**Case Number: ZC-25-191**

## Zoning Map Amendment

**Site Location:** 5736 Wilbarger Street

## Wilbarger Industrial Site Plan

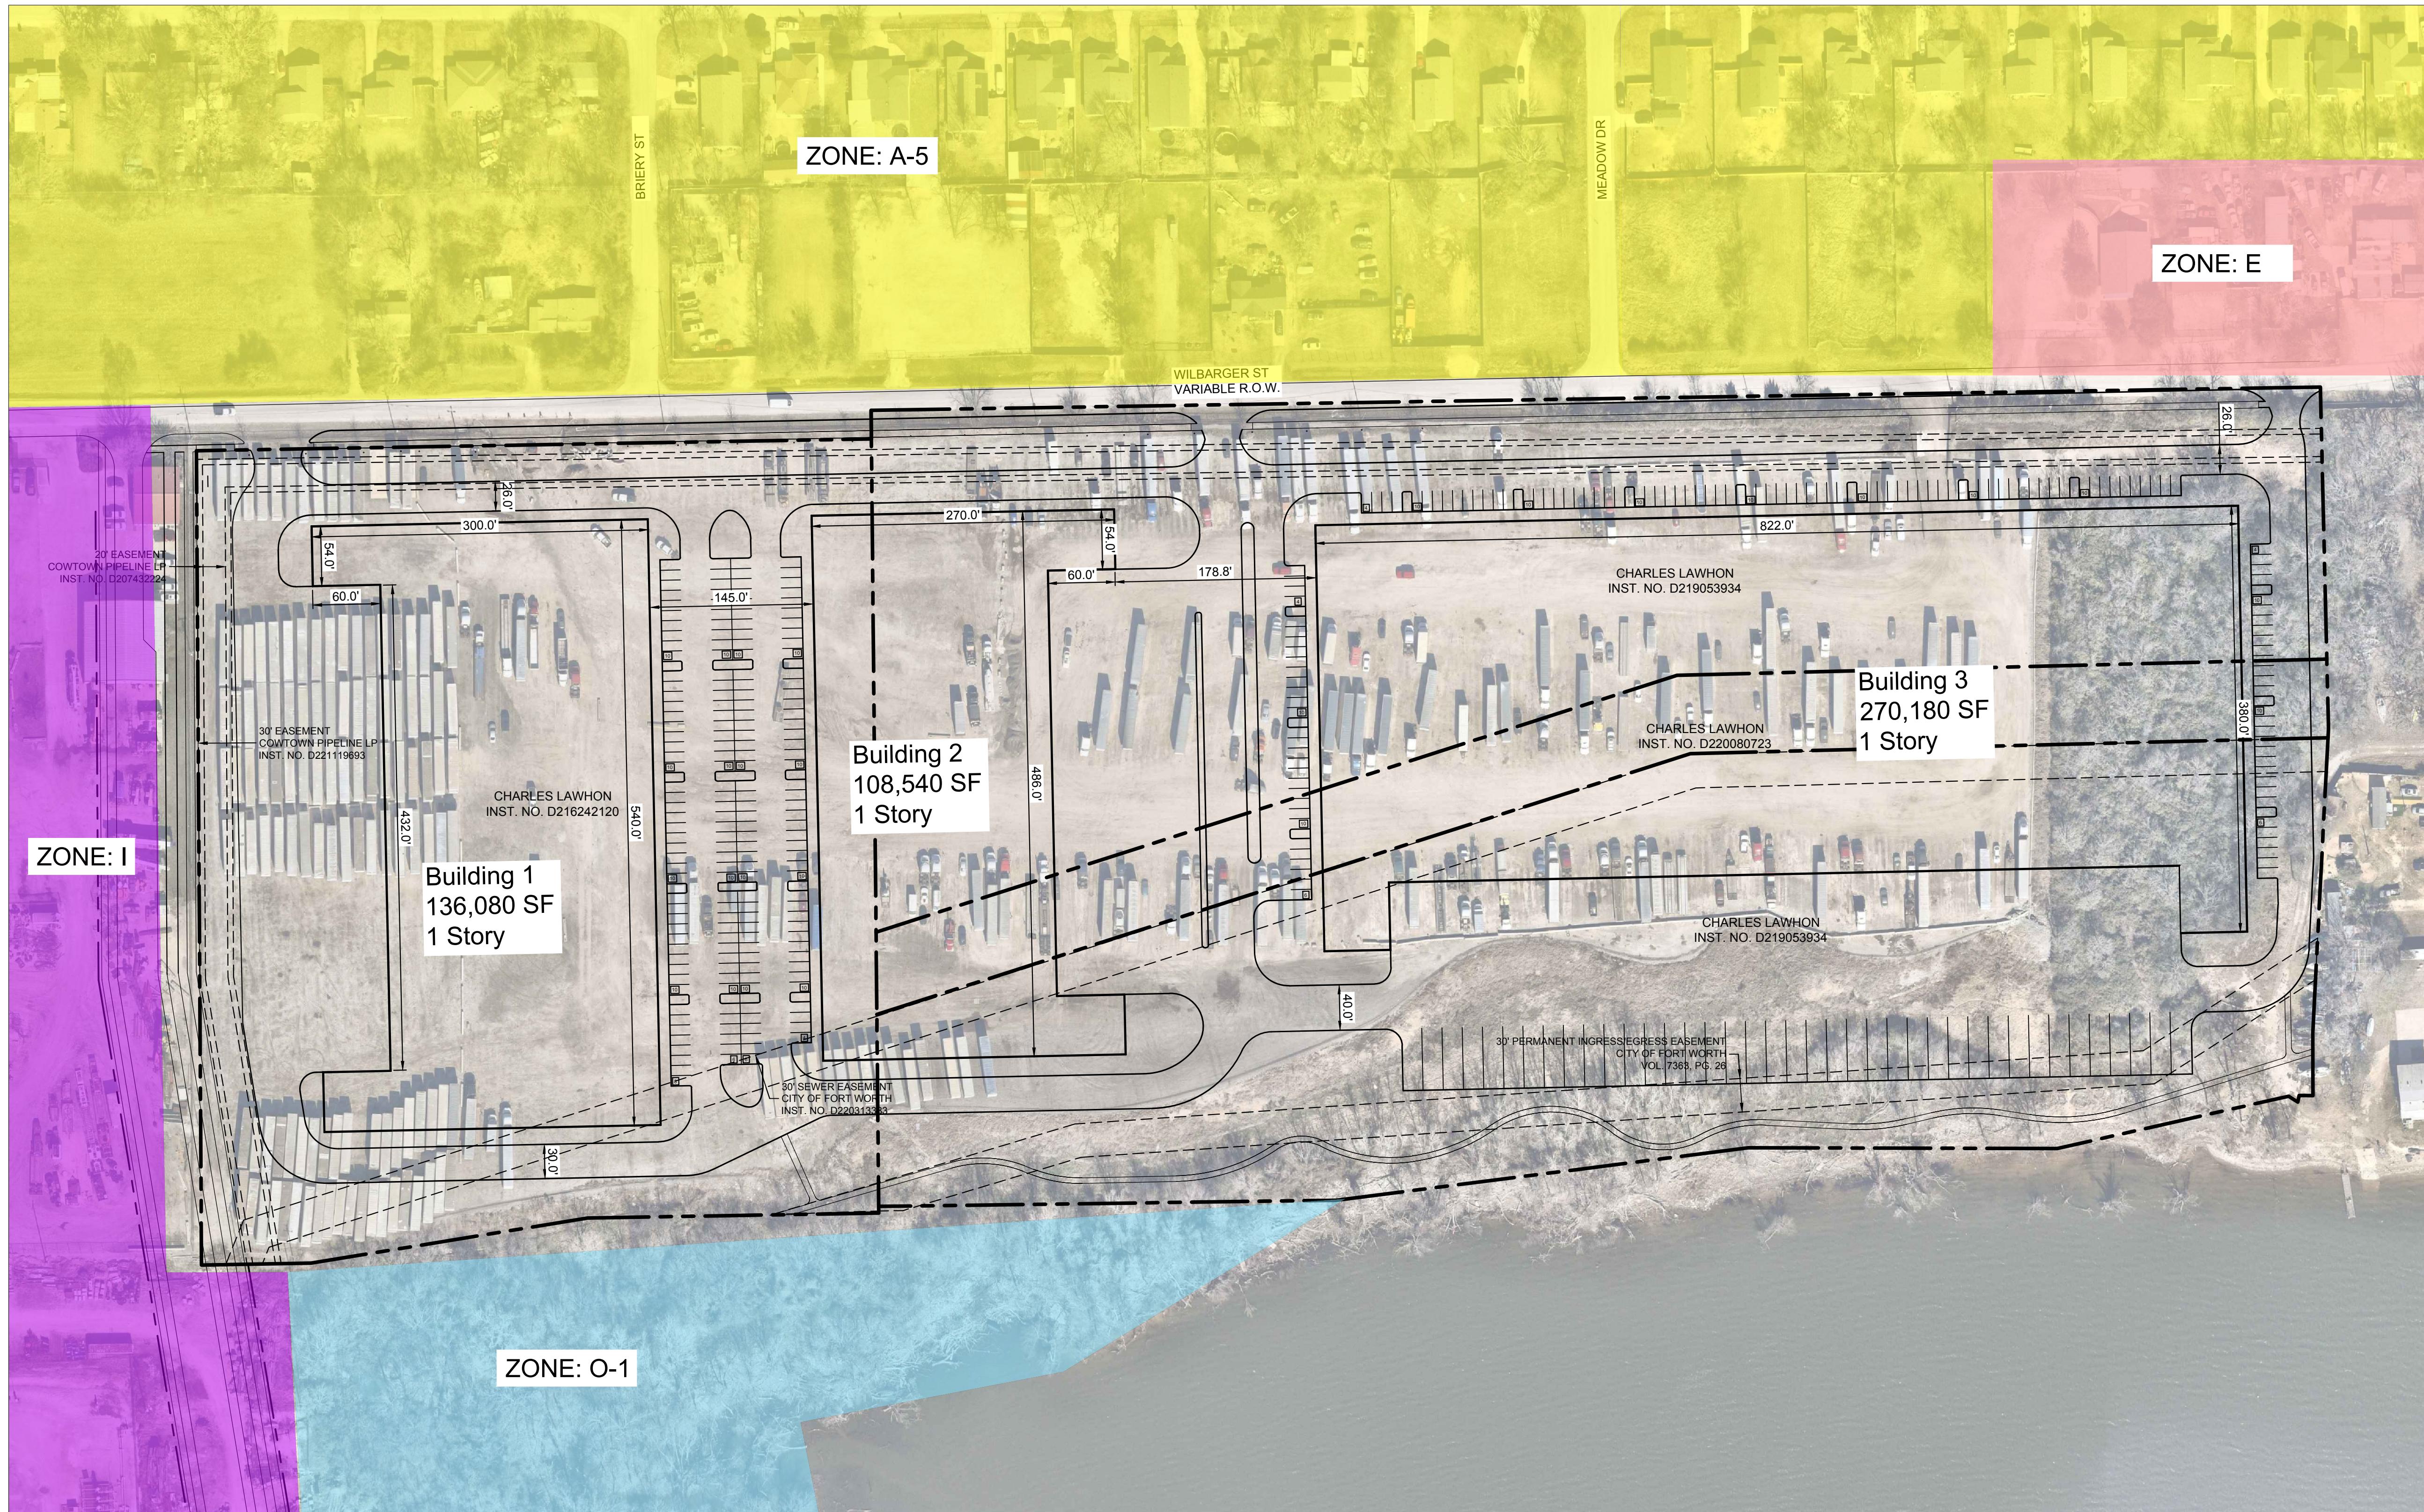
5. All 3 buildings shown are in the northern 30-foot sewer easement. Move the buildings out of this easement.
6. Show the proposed MTP alignment of Lakeshore Boulevard in its full 110-foot width.

7. Label Lake Arlington.
8. Show the AE flood zone and the corresponding X-shaded buffer. Buildings are not allowed to be in these flood areas.
9. Note the specific land use of each building.

10. Note the building heights and exterior construction materials.
11. Show all entrances and exits to the buildings, including all overhead doors.
12. Show all paving and ROW widths.

13. Show the parking calculations for the buildings' uses.
14. Number the semi-truck parking spaces on the southern side.
15. The semi-truck parking is likely to cause the site to be over-parked and more trees to be planted.

16. Show ADA spaces and access ramps.
17. Show and label the fire lanes.
18. Show internal vehicular circulation patterns.
19. What is the unlabeled winding area along the southern property line?

20. Create a surface materials legend and add these colors/patterns to the main site plan. Include the surface materials of all ground level areas, including the paving, parking, and open spaces.

21. It is not readily discernable how the site will meet the 4% landscaped area with 75% of the required area in front of the buildings.
22. The site is not meeting the required tree preservation standards. The site is currently zoned UR, but the proposed site plan does not appear to comply with those standards. This development will be considered industrial land use for the UF calculations. The existing canopy approved to be preserved under UFC17-0076 must remain preserved, and the development must provide 20% canopy coverage with 40% of the employee/customer parking area being covered as well.

23. Show the dumpster locations and their enclosures. Label the height and materials of the dumpster enclosures.
24. Parking is not allowed in the front yard due to the projected front yard requirements from the UR zoning to the east. Move the parking spaces out of the projected front yard.

25. Dimension the front landscaping along Wilbarger Street.
26. Show and label all setbacks, based on the 35-foot residential front yard to the north and other residential setbacks.

27. The City's maps are showing the southern easement to be another sewer line, instead of an access easement. Document this easement's use with an email from the Water Department.

28. Label the site's current zoning and land use.
29. Label the land use of the surrounding properties in all directions.

30. Show the monument sign locations and the required visibility triangles.
31. Comments may be revised or added when additional information is provided.

1. Site contains segment of Lake Shore MTP, not shown on site plan.

Fire access roads must be constructed above the 100 year floodplain.  
Section 503.4 Obstruction of Fire Apparatus Roads

Additional fire hydrants are required to meet the following for each building.  
Maximum of 600 ft. (300 ft. radius) of space between hydrants along a direct horizontal line, and  
Maximum of 500 ft. hose lay distance to all points of building.  
Maximum of 150 ft. for a standpipe system, and/or a sprinkler system.  
Sections 507.5.1 (2) and (3) Hydrants

Marked fire lanes are required for each building that provide hose lay within 150'. The 300' increase in hose lay is not allowed for buildings considered high piled storage (having clear ceiling heights of 14' or more, Chapter 32) or hazardous materials uses (Chapter 50).  
Fire lanes Section 503.1.1 Buildings and Facilities.

1. TDS does not support this zoning change and PD site plan request.
2. Traffic Impact Analysis will be required to understand the impact of this development on the surrounding transportation network. Contact TDS@fortworthtexas.gov for more information or questions. Building 3 will be assumed to be high-cube (sort) development until additional details indicating otherwise are provided.

3. Site does not conform to the Master Thoroughfare Plan. Lake Shore, a Commerce/Mixed-use thoroughfare is planned through this site. MTP ultimate cross-section code: CMU-L1-T0-TWLT-PA-BOP (110').

4. Current proposed driveway locations appear to possibly not meet driveway spacing requirements of the Access Management Policy. Exhibits showing the driveway spacing from other driveways (including neighboring properties) and streets are necessary before TDS can support that aspect of the site plan. Any MTP alignment amendment will change the driveway location requirements.

5. Sidewalk/side path width requirement may not be as shown in the proposed site plan, depending on proposed width and any potential MTP alignment changes

6. Driveway throat lengths may not meet Access Management Policy requirements
7. See TDS notes from PDC-25-0325 held on 10/07/2025
8. Site will need to conform to the standards of the Access Management Policy, Transportation Engineering Manual, Master Thoroughfare Plan, and other applicable transportation-related manuals and guides in use and adopted by the City of Fort Worth.
